Permit No: 33-7178

STATE OF IDAHO
DEPARTMENT OF WATER RESOURCES
BENEFICIAL USE FIELD REPORT

Date: May 25, 2005
To: Water Right File 33-7178
From: kwilson
Re: Field Report Narrative

HYDROPOWER

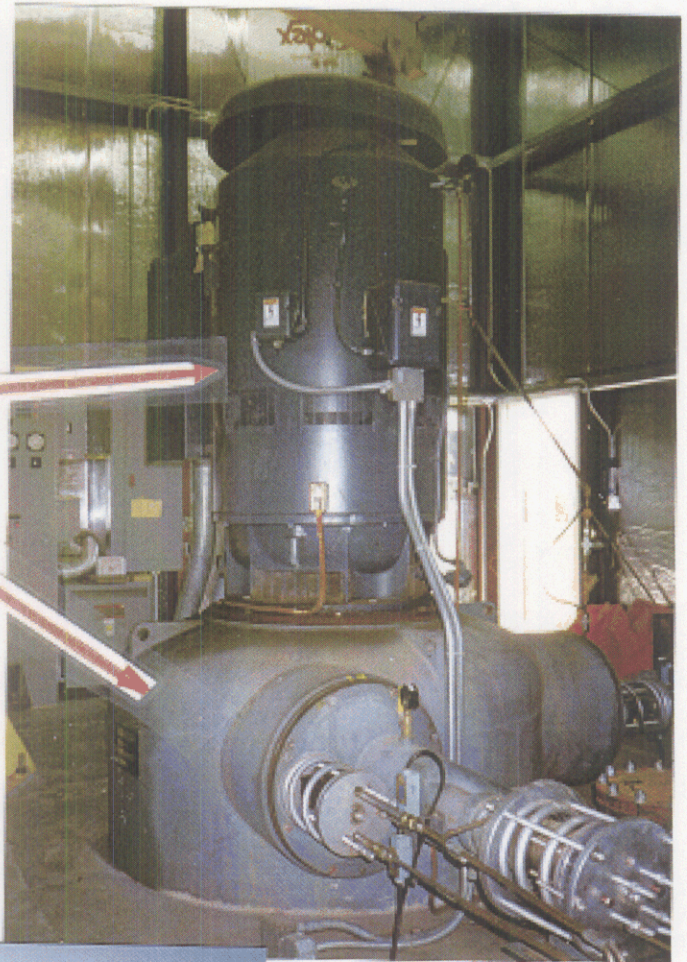
DIVERSION DAM with 16" mainline to hydropower plant open
discharge into ditches for irrigation or discharged into Little Lost
River.
